Corrigendum – X- dated 19/01/2026 to CPC Tender No. BHEL/CPC/KOD/EPC-DBA/26/035

Corrigendum – X, dated 19/01/2026 to CPC Tender No. BHEL/CPC/KOD/EPC-DBA/26/035 - Dry Bottom Ash Handling System-EPC Package (Package-I) of Unit#3 & Unit#4 at 2x800 MW DVC Koderma Ph-II, Jharkhand.

A) Modification in TECHNICAL CONDITIONS OF CONTRACT (TCC) Volume-IA: Following clauses are hereby modified in TCC:

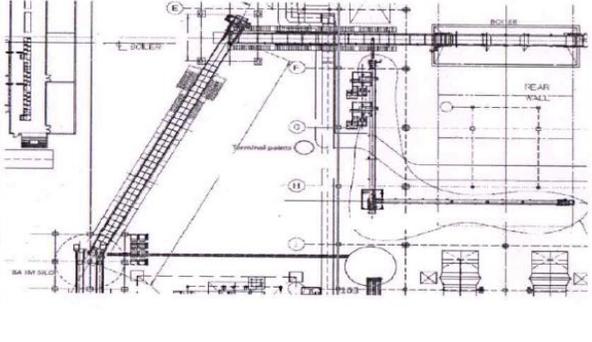
31	Corrigendum – IV dated 16/12/2025 to CPC Tender No. BHEL/CPC/ KOD/EPC-DBA/26/035 Sl. No. 141-Surface Preparation & Painting	BHEL Clarification: Tender Condition shall prevail. Bidder to comply with technical specification requirement.	Based on its proven experience, MP proposes the following painting cycles for the Equipment (hot resistant paint) <ul style="list-style-type: none"> • Surface Preparation: EN12944 SSPC SP10 Sa 2.5 • Primer: Inorganic Zinc Rich Primer No.1-layer 75 micron • Finishing: Silicone Aluminium No.1-layer 25 micron • Total Dry Film Thickness= 100 micron 	Bidder's standard proven practice is acceptable subject to approval of DVC/BHEL during detail engineering.
32	Corrigendum – IV dated 16/12/2025 to CPC Tender No. BHEL/CPC/ KOD/EPC-DBA/26/035 Sl. No. 133	BHEL Clarification: Refer corrigendum being issued for Economizer ash data at various boiler load. Cooling water required in emergency condition for BMCR load shall be indicated by bidder in their offer for our review.	According to the thermal calculations, bidder provides the following table with the air/water cooling requirements for the different operating conditions. See document: MP.2024.0162-TNG-R00 (attached)	Comment attached (Annexure-4) on the air/water cooling requirements.

DWG NO.-3112-108-POM-A-910

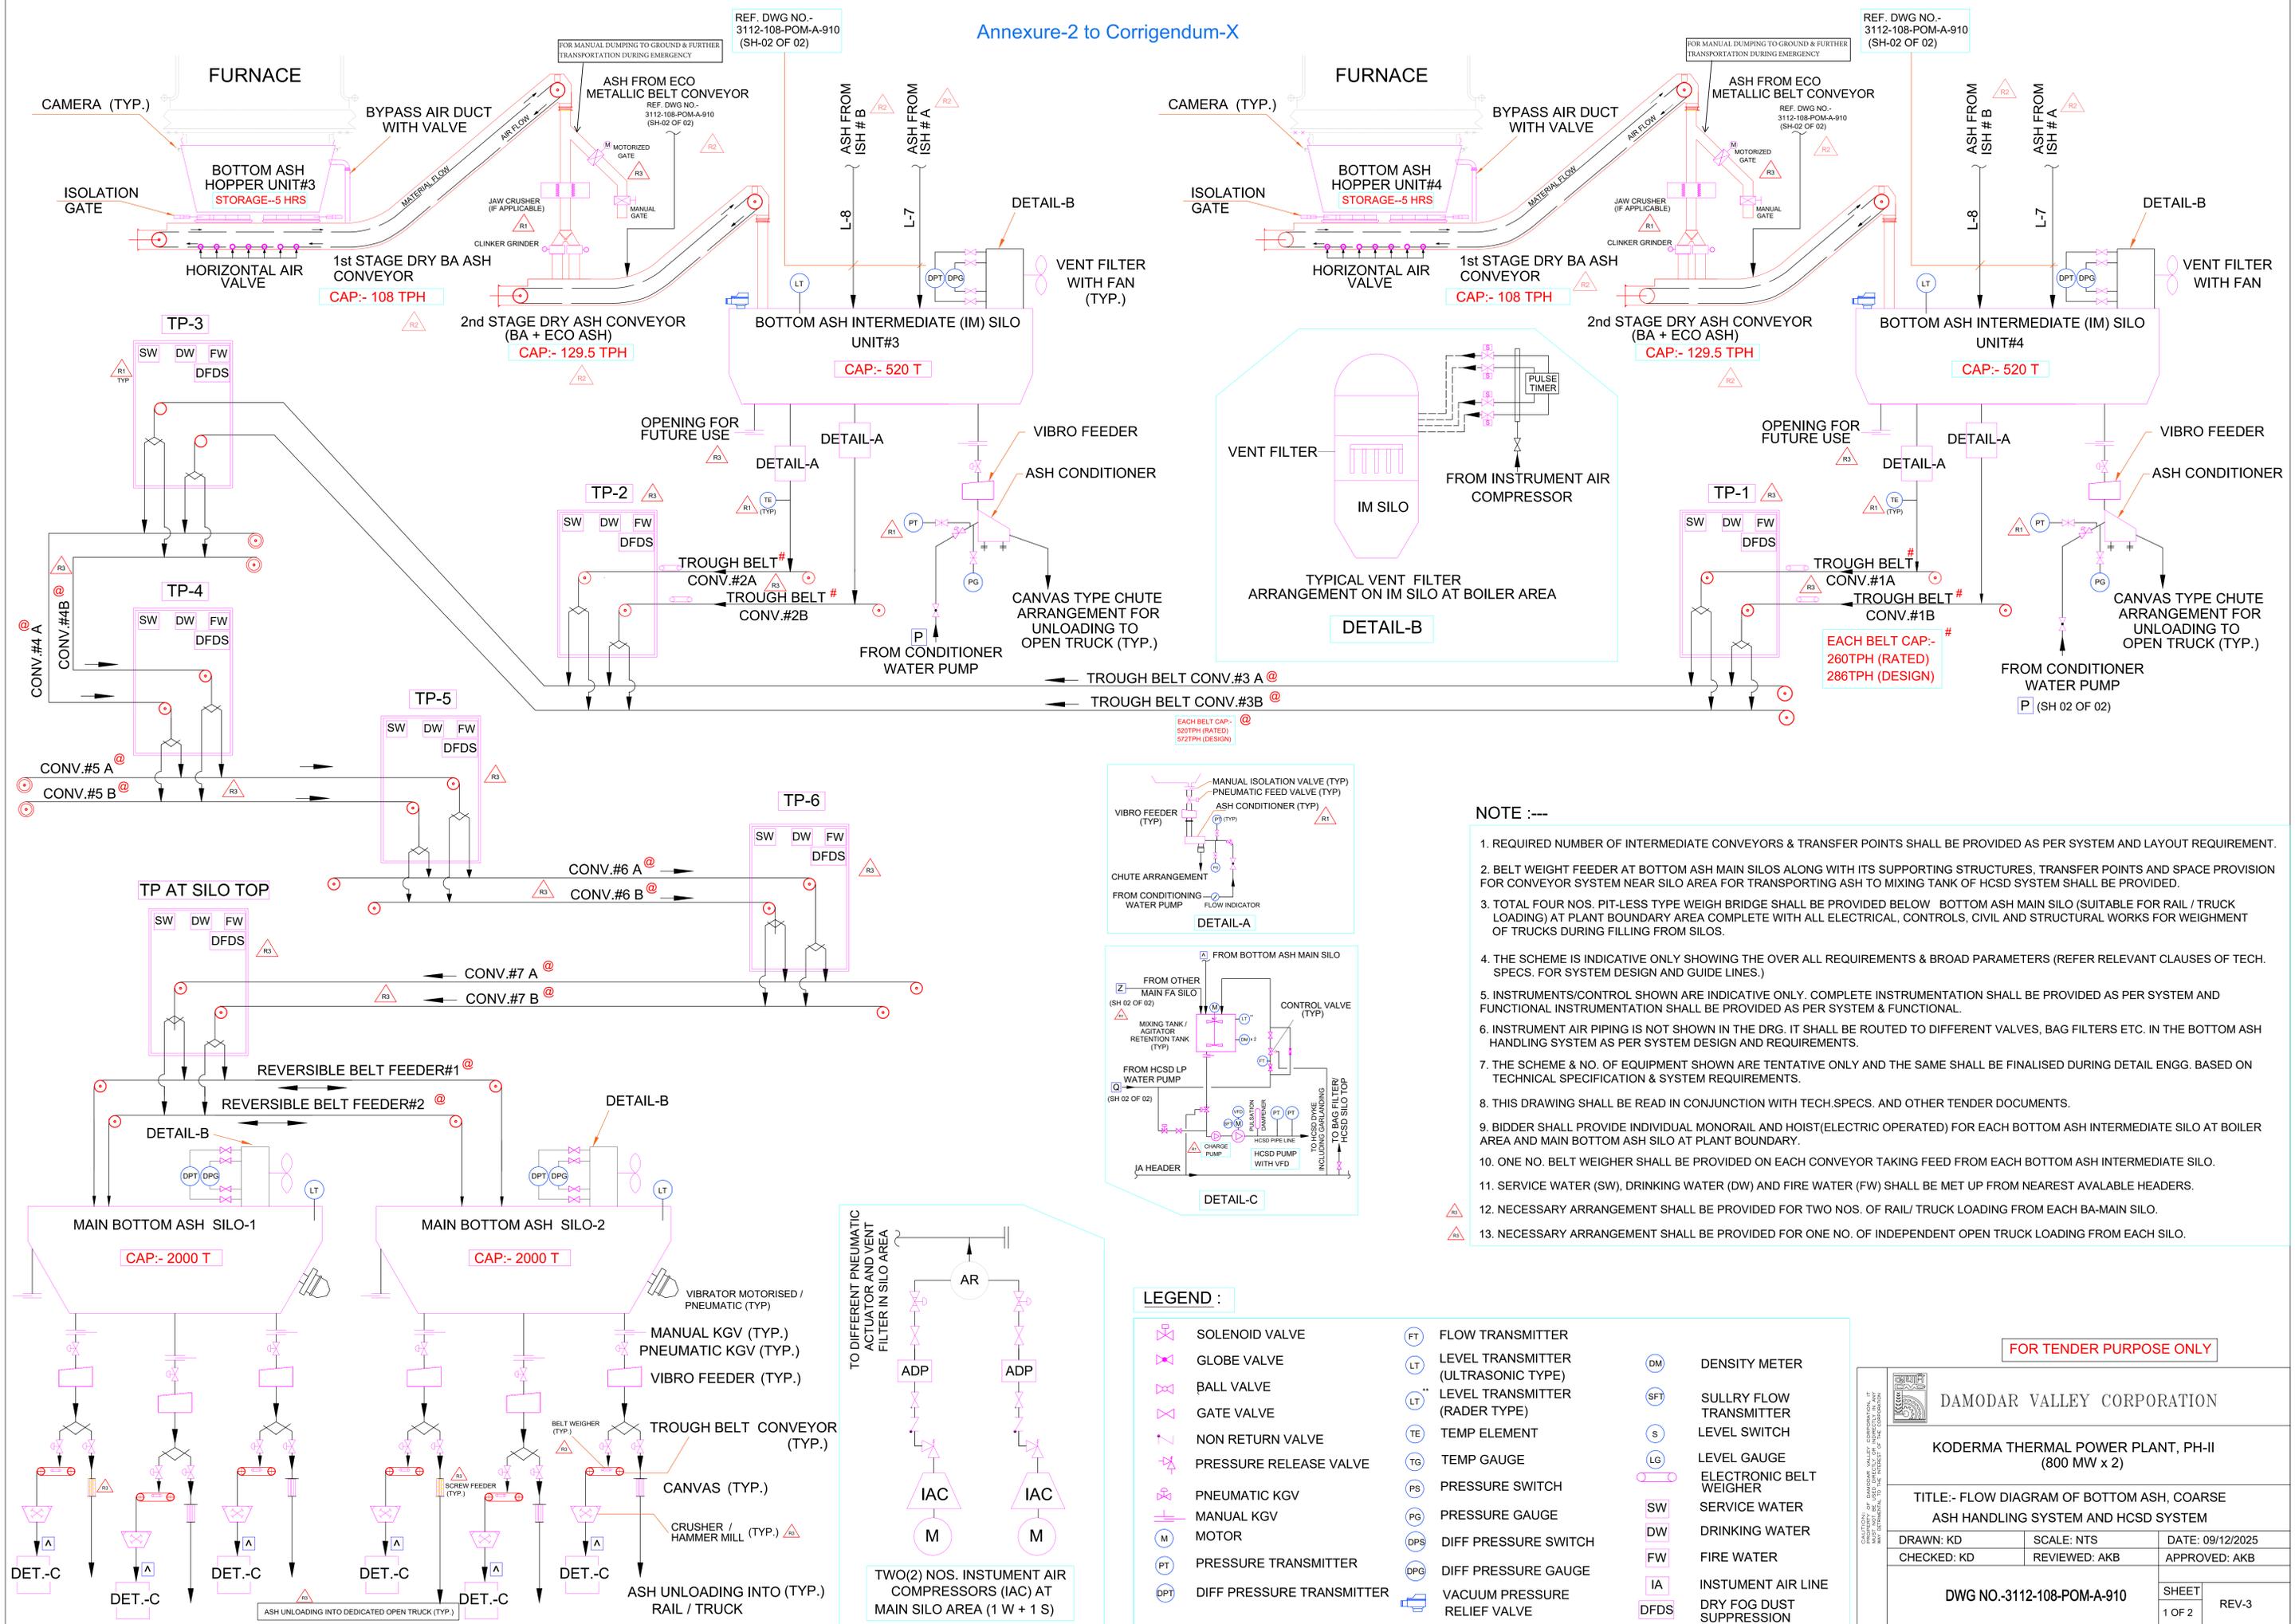
6	Flow Diagram of Bottom Ash, Coarse Ash Handling System and HCSD System	--	Flow Diagram of Bottom Ash, Coarse Ash Handling System and HCSD System	Bidder shall read as Motorized Flap Gate in place of Motorized Gate indicated in the provision of manual dumping to ground of Flow Diagram BA, CA and HCSD System-Rev 03 (Annexure-2) .
